AMENDMENTS TO THE DRAWINGS

REMARKS

In response to the Office Action mailed March 31, 2005, Applicants respectfully request reconsideration.

Fig 1
(Prior Art)

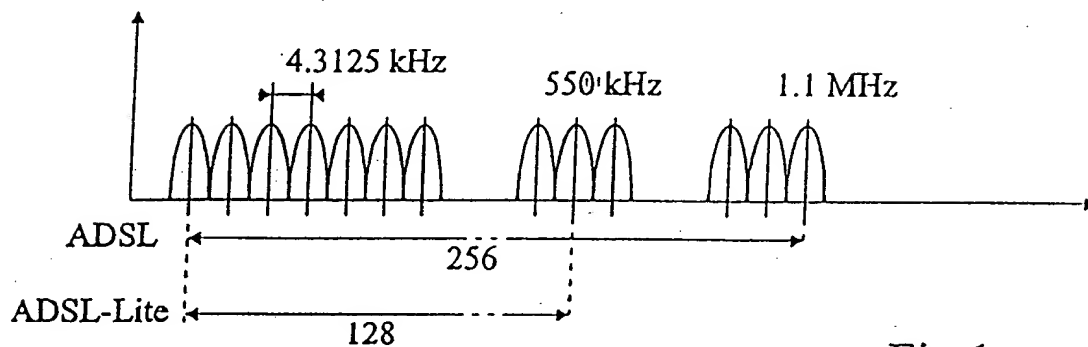
On pages 3-4, the Office Action states that Figures 1-4 should be designated by a legend such as --Prior Art--. This legend has been added to the drawings. Review and approval of the proposed drawing corrections is respectfully requested.

Enclosed is one (1) sheet of proposed drawing corrections for Figures 1-4. The proposed corrections are marked in red ink. Review and approval of the proposed drawing corrections is respectfully requested.
